**Rix's Creek Extension Project (SSD 6300)  
Response to Submissions Addendum**

## Attachment A

**Figure 1:** Past disturbance areas (in blue) which fall outside the Alternative Conceptual Mine Plan endorsed by the consent for DA 49/94 and the currently proposed 'Rix's Creek Continuation Project' areas (ie the proposed disturbance area) including the addendum areas identified in the RTSA.

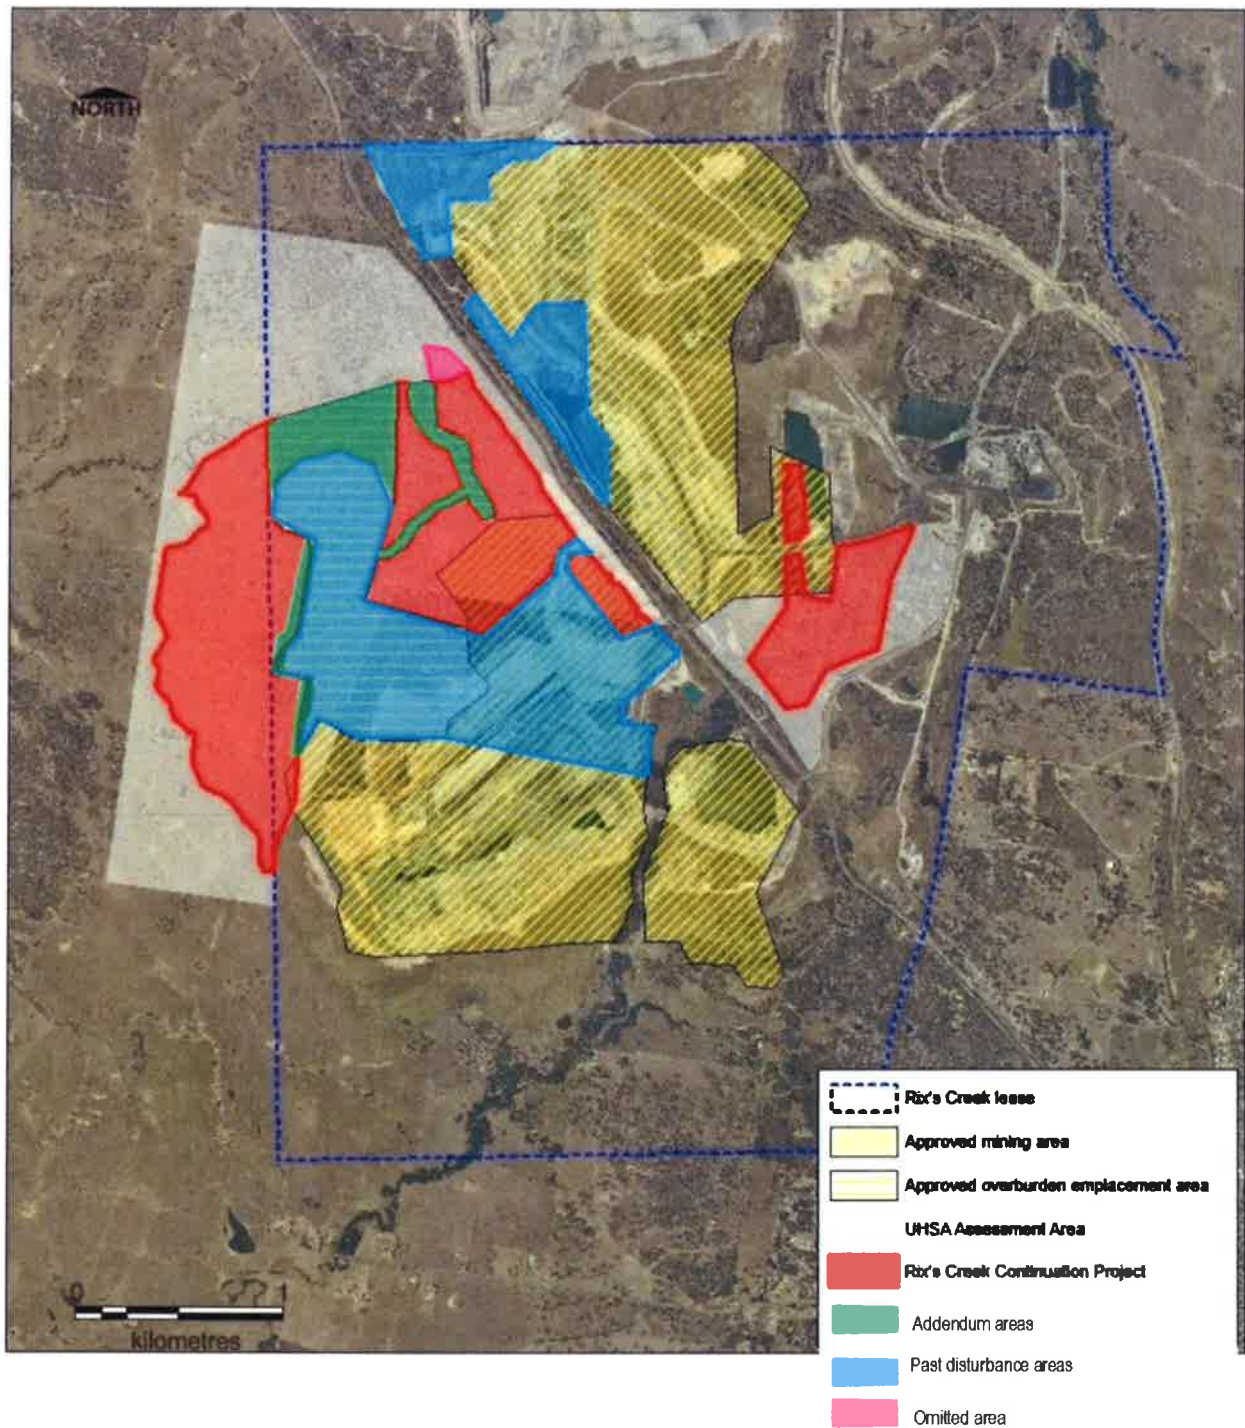
The Department has reviewed the RTSA report and is not satisfied that the 'addendum area' used in that report resolves all gaps in the existing impact assessment study areas for the Rix's Creek Extension Project taking into consideration the existing approved area of disturbance under DA 49/94 and the proposed disturbance area (ie the 'investigation area' identified in Figure 1 of the RTSA report). In the Department's view, there are past disturbance areas outside of the area approved for disturbance under DA 49/94 that have not been included in the 'addendum area' presented in the RTSA report and have therefore not been subject to an assessment in either the Project's Environmental Impact Statement (EIS), RTS, or the RTSA report. These past disturbance areas are identified in blue on the attached Figure 1.

The Department's analysis of these two issues and further comments are set out in **Attachment A**. It is requested that the RTSA report is revised to include an assessment of all past disturbance areas as well as the small area of additional disturbance proposed but not assessed, as shown in Figure 1. In addition, the Department is requesting a series of figures to clarify and resolve the current inconsistencies between figures in the EIS, RTS and RTSA report, as set out in **Attachment A**.

*Note: \*Past disturbance area' refers to disturbed land that in the Department's opinion falls outside of the Alternative Conceptual Mine Plan approved for disturbance under the consent for DA 49/94 that is not within the 'Rix's Creek Extension Project' area (ie the proposed disturbance area as set out in the project's EIS and RTS) and the addendum area (as set out in the RTS). See also Figure 1.*

NB. The 'approved mining area' and 'approved overburden area' are as identified by Bloomfield in the current EIS. The 'omitted area' is within the proposed extent of mining (see EIS Figure 1-4).

The Department considers that revised and updated drawings are required to resolve these inconsistencies, and requests both separate drawings and a final drawing with the following features overlaid:

- existing development and approved area of disturbance under DA 49/94;
- the proposed area of disturbance, including delineation between overburden emplacement and mining areas; and
- overlays of relevant impact assessment study areas on the existing approved and proposed area of disturbance to support the gap analysis.
